CONTRACT CHANGE ORDER NO._____
SHEET_____ OF _____

DETAILS
SCADA REMOTE TERMINAL UNIT SYSTEM
RTU #12E CONNECTION DIAGRAM
NO SCALE

E-909

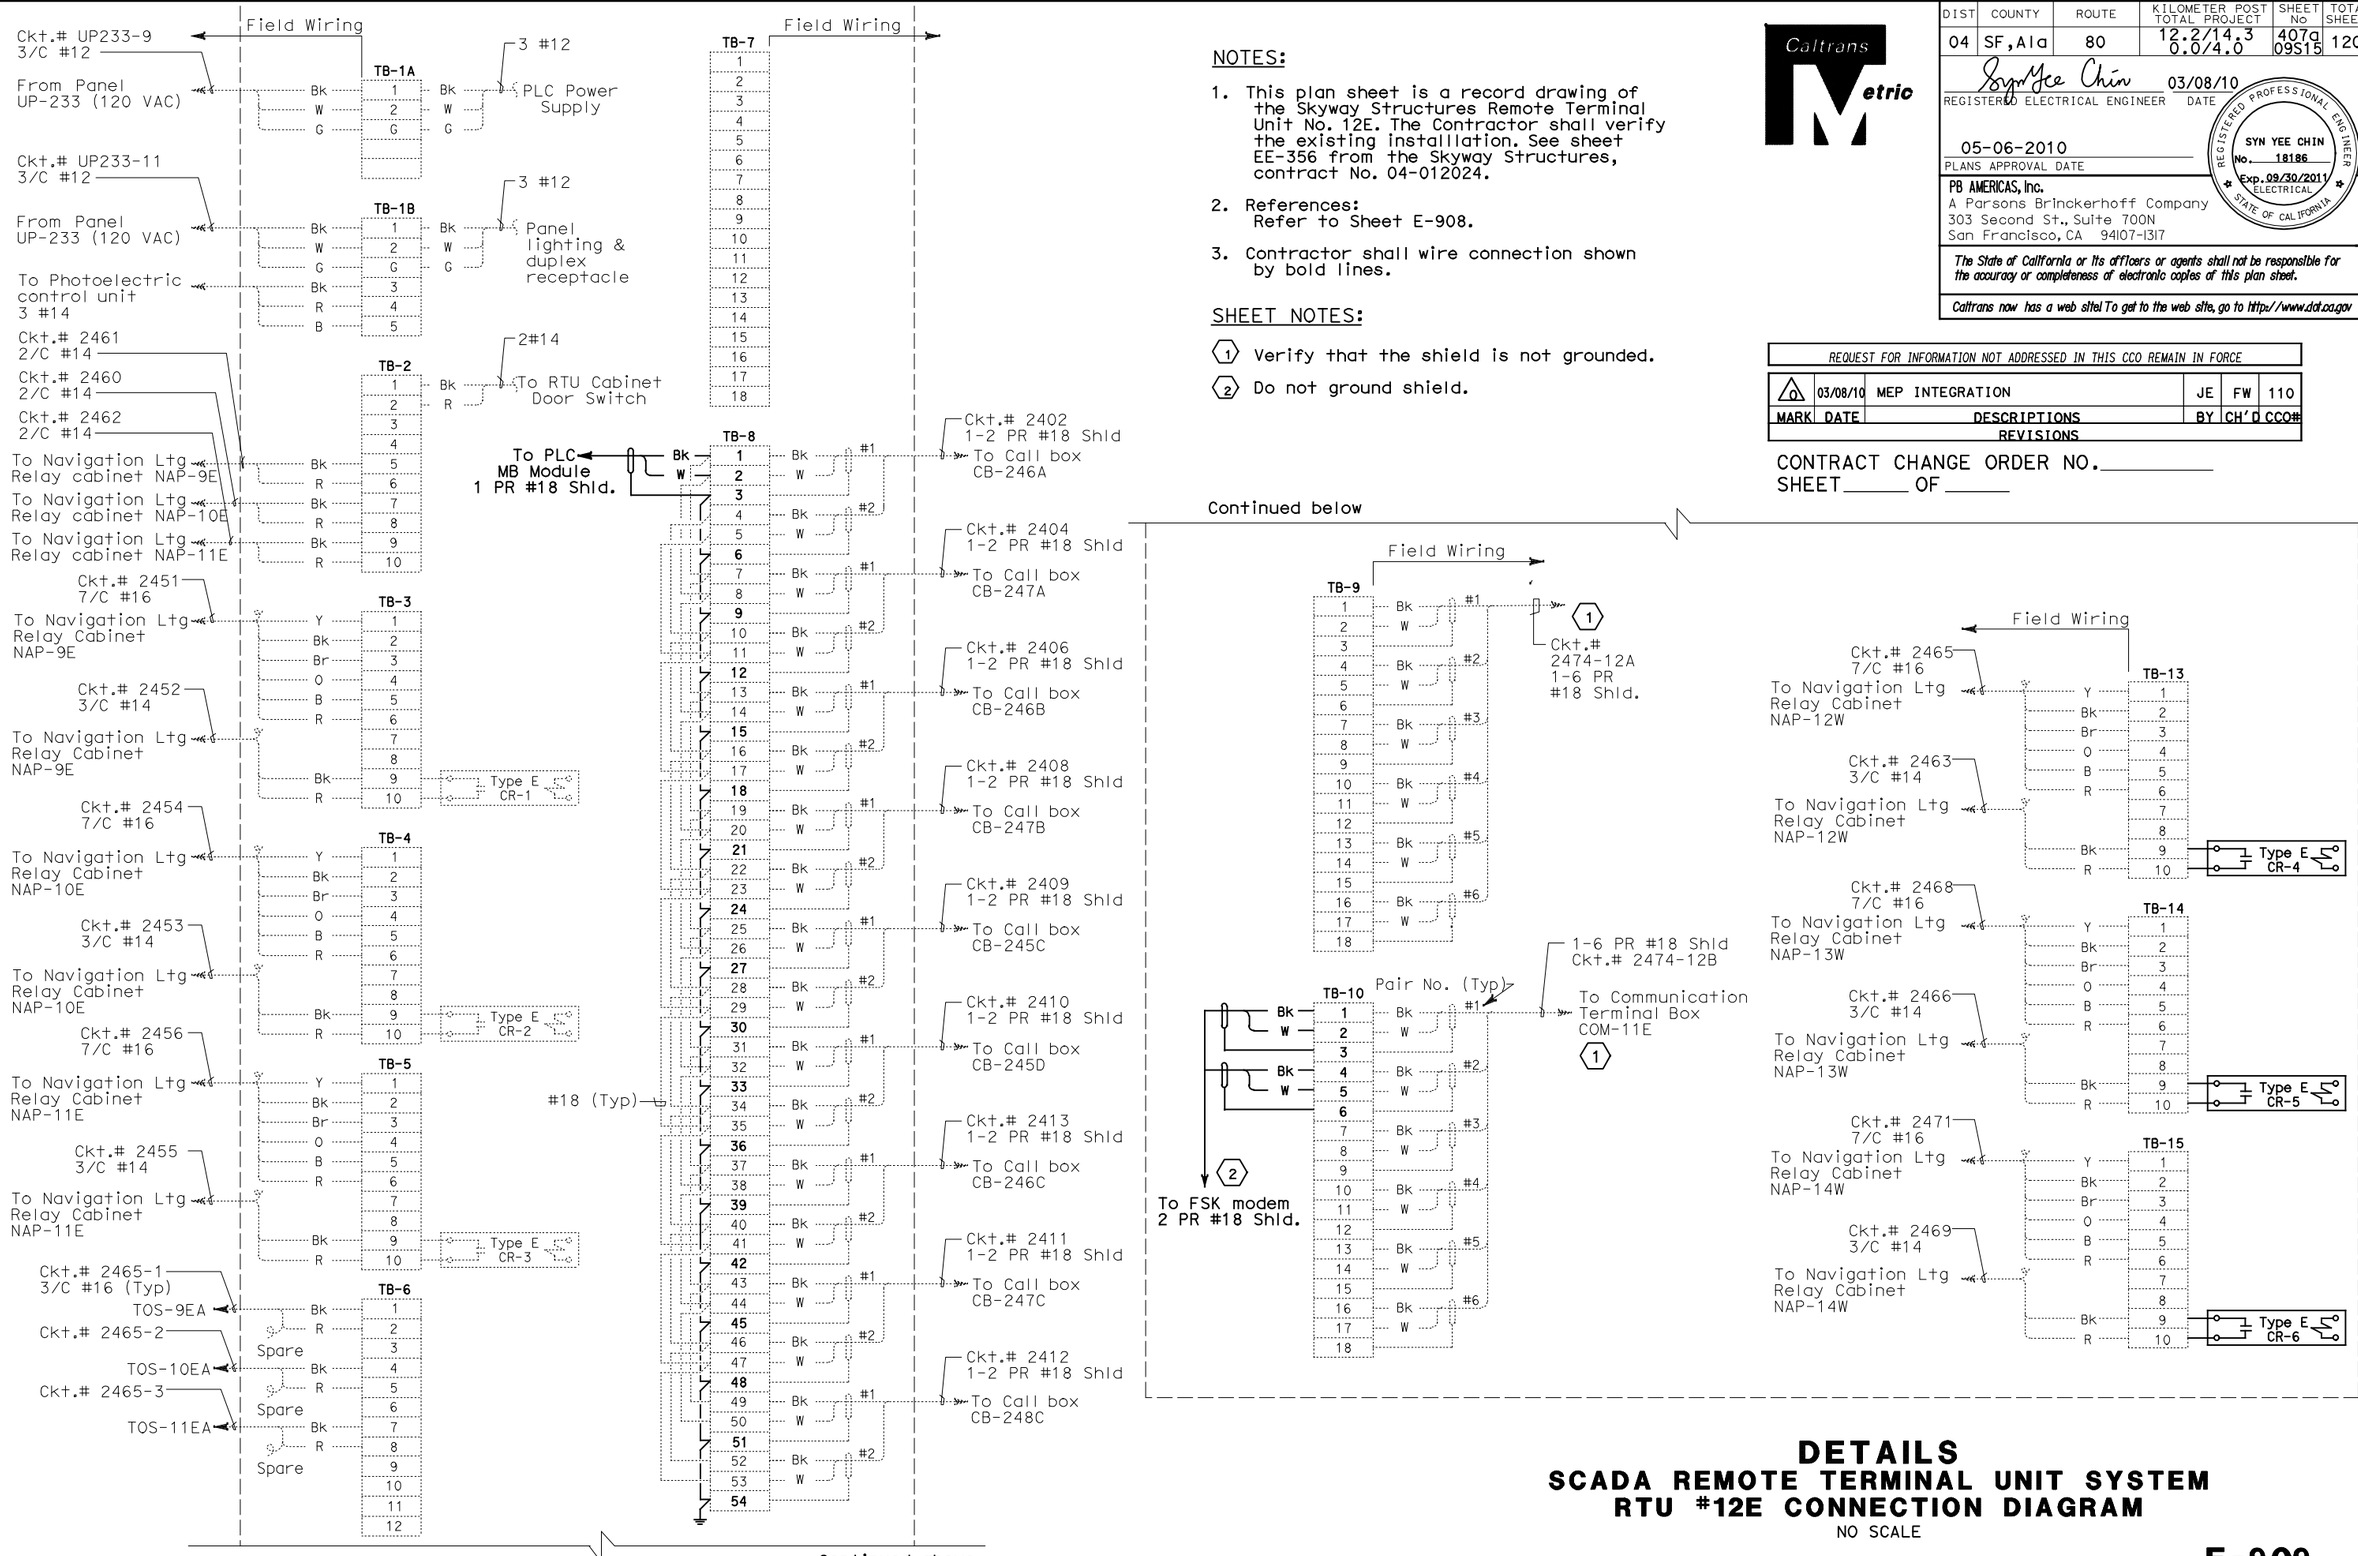
MARK	DATE	DESCRIPTIONS	BY	CH'D	CCO#
0	03/08/10	MEP INTEGRATION	JE	FW	110

(1) Verify that the shield is not grounded.

(2) Do not ground shield.
